城規會編號：TPB/A/YL-SK/435

提議雨水渠務報告 (Proposed)

事項：回覆 2026 年 1 月 12 日信函的部門意見

Photo c3-2

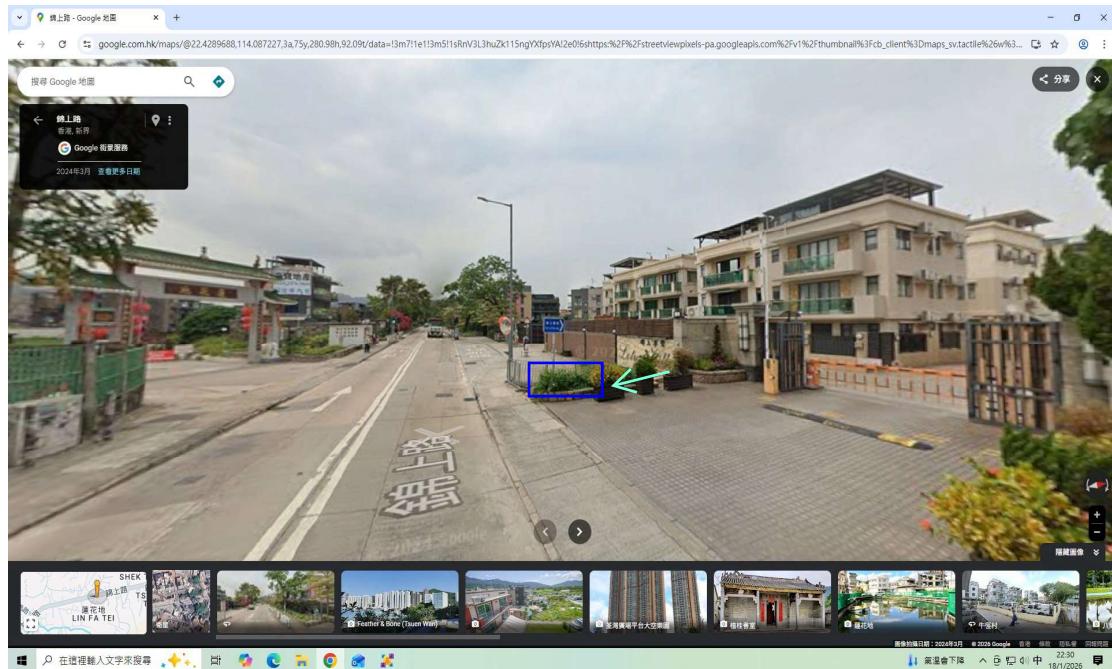
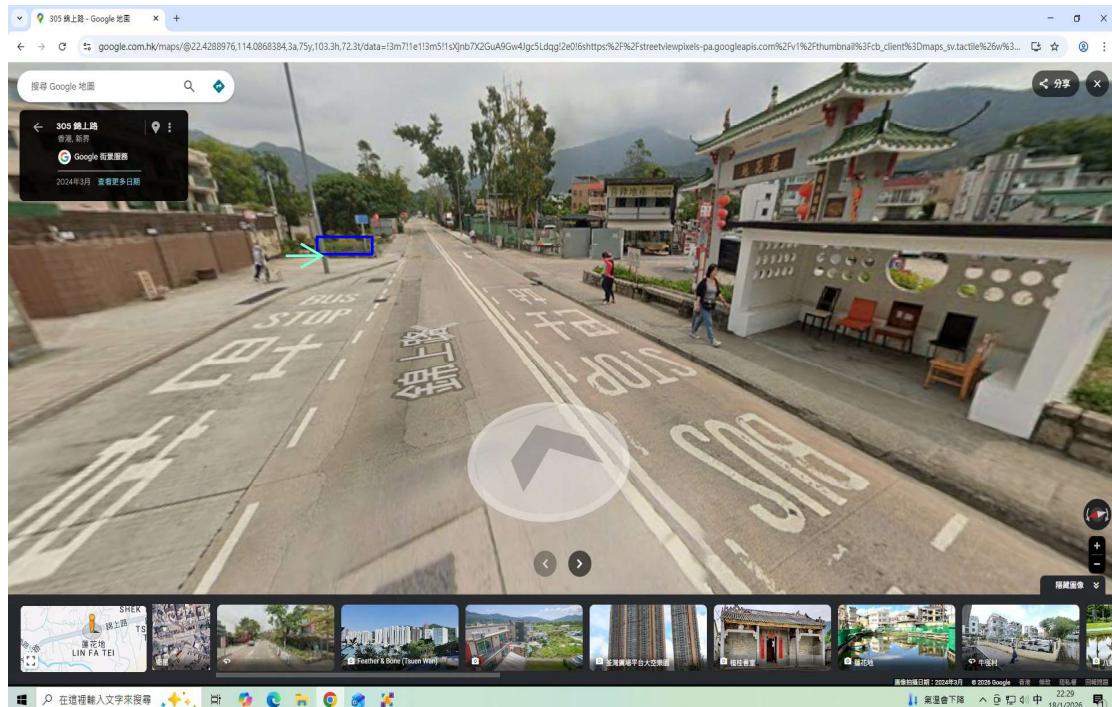
(d) The submitted site photos cannot indicate and show the current conditions of the existing 600UC. Please provide more site photos at different views and locations for review.	在c3-2和4-2中示

e3-2

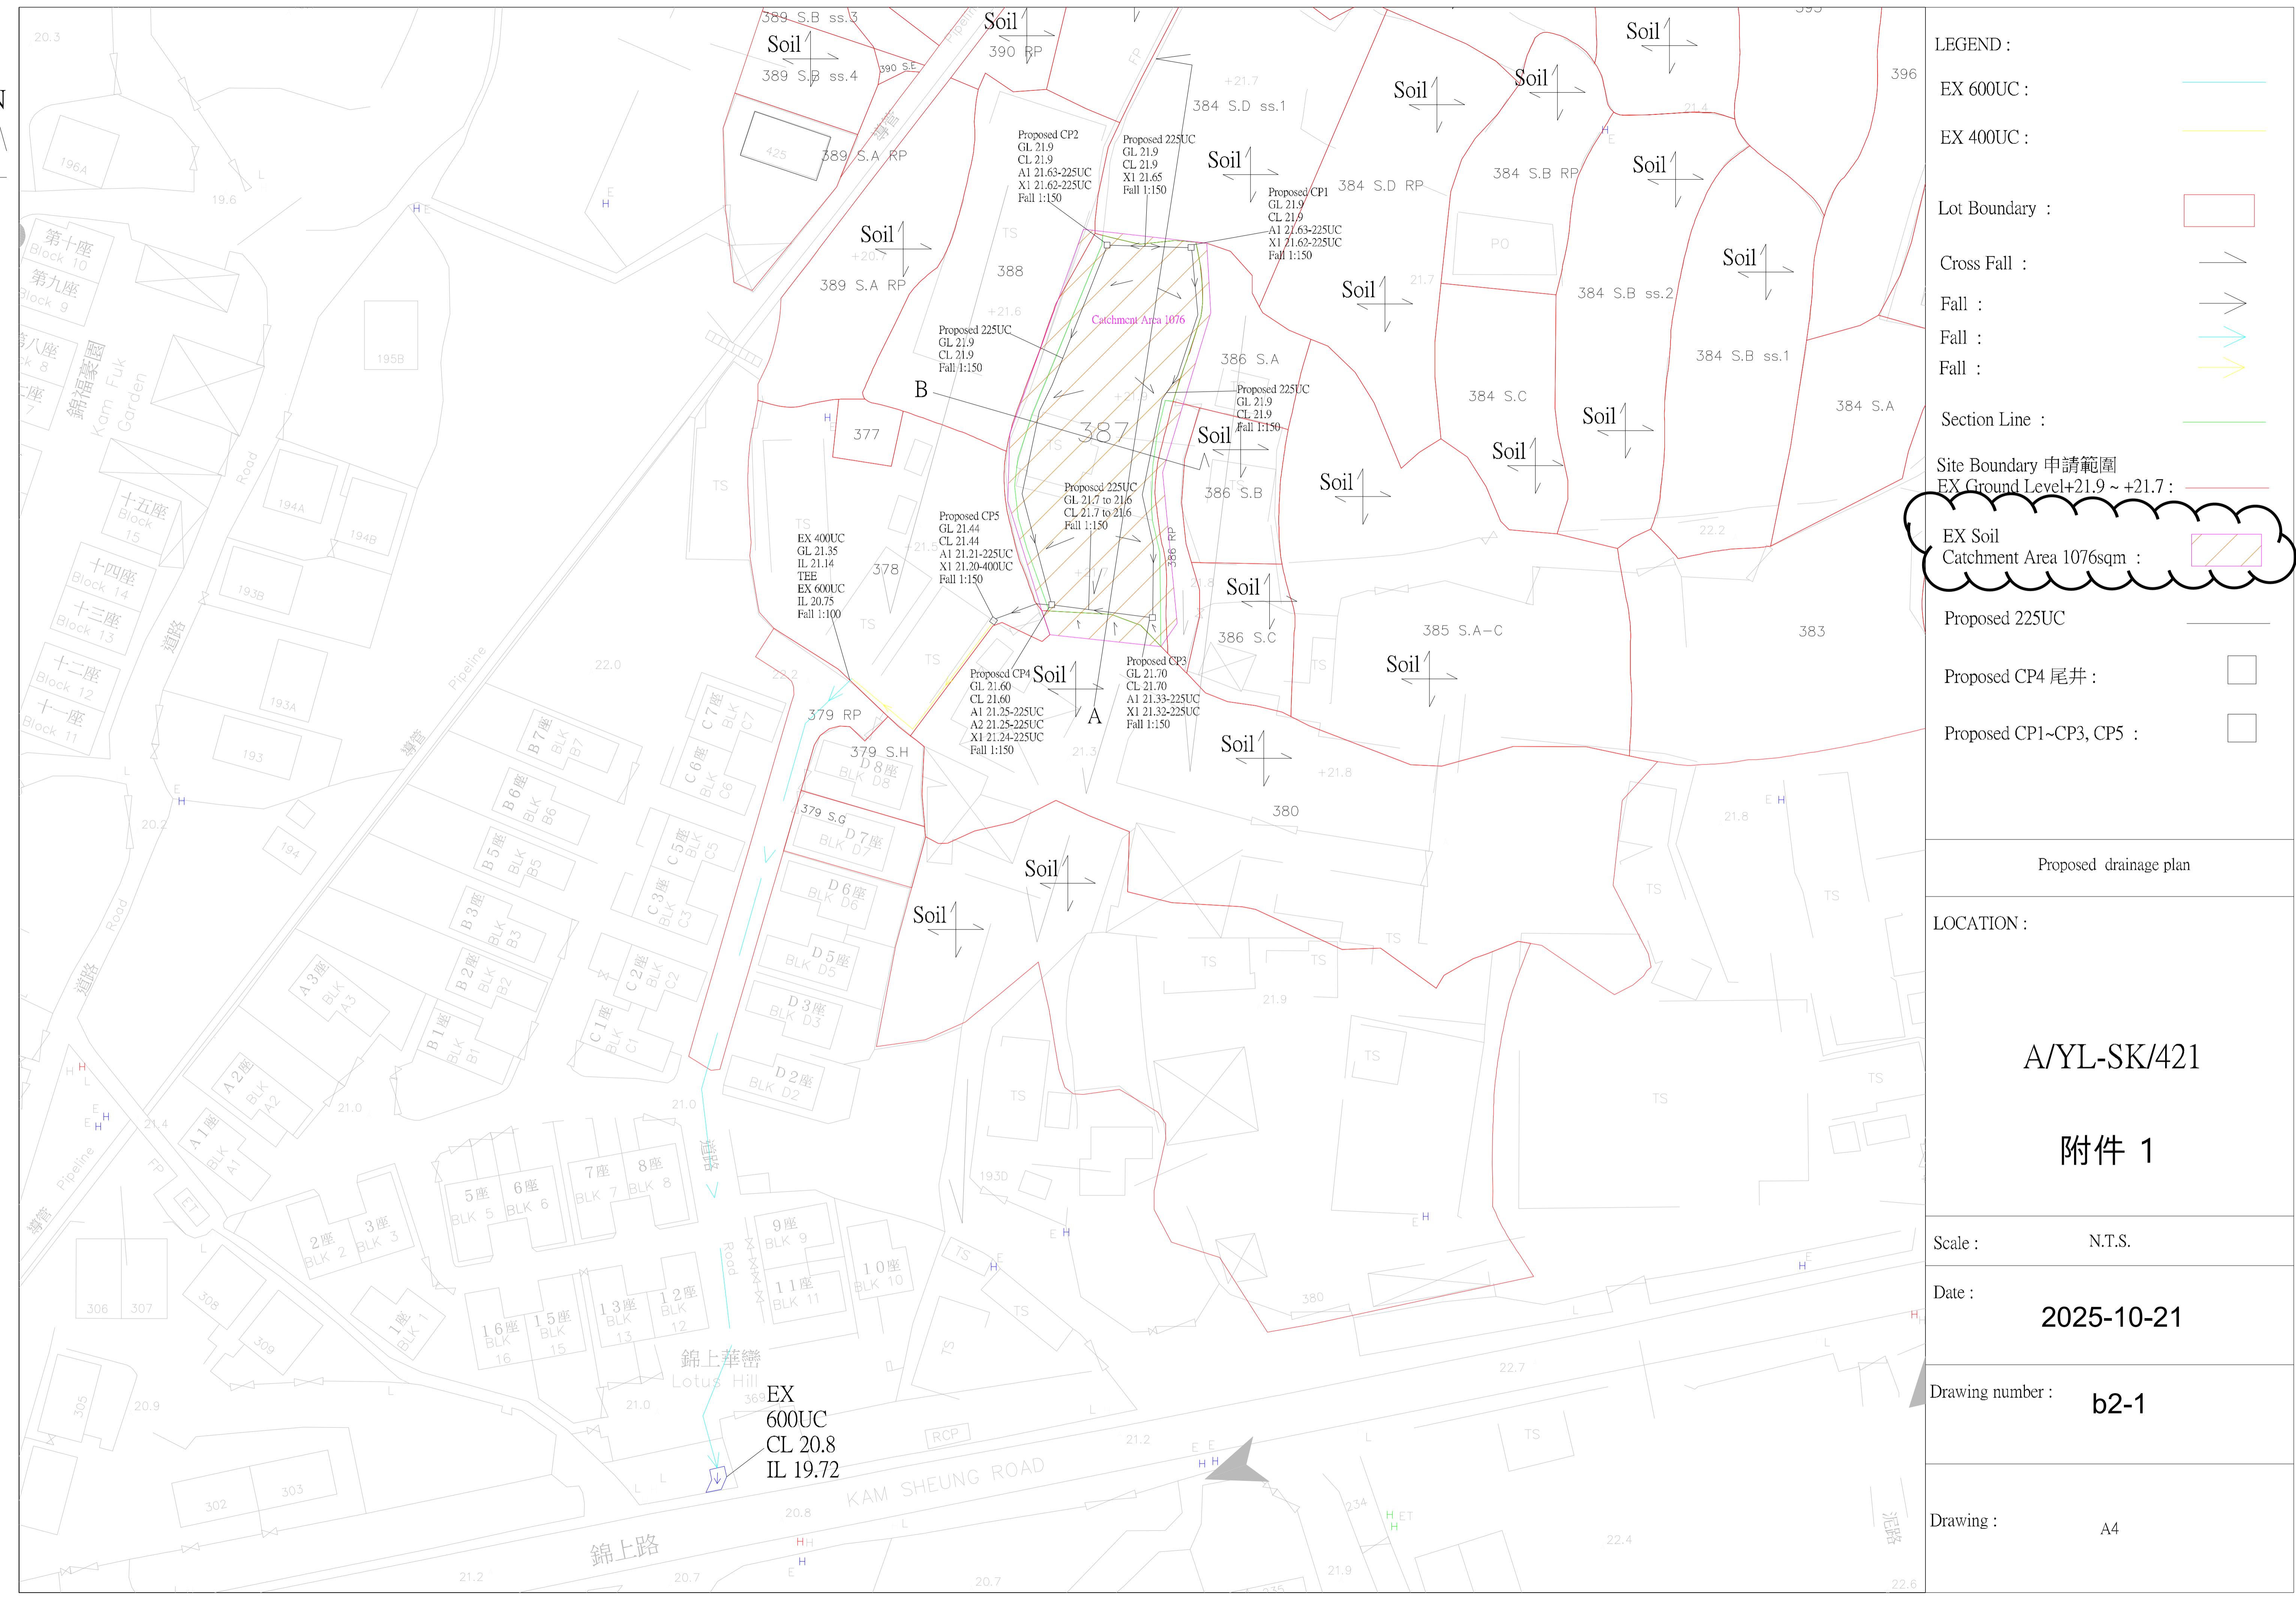
A_YK-SK_435	
20260112 Comment	回答
(a) The drainage system from the application site of A/YL-SK/421 was proposed to be discharged to the proposed u-channel between CP6 and CP7. Please take into account the increased drainage quantity for the assessment. Please also make reference to the latest Technical Note No. 1 issued by DSD for more details in preparing the drainage proposal. Please upgrade all drainage facilities size and/or gradient accordingly.	在e1-2 至e3-2中示, 附件1至附件4(SK/421)資料

EX 600UC
Q(m³/s) = **0.769076 m³/s**

SK421 & SK435 to (EX 600mm U-channel)
% = **0.769076**
% = **0.085875**
Q(m³/s) = **11.2** % OK

Drainage Impact assessment report of 600mm U-channel is Acceptable
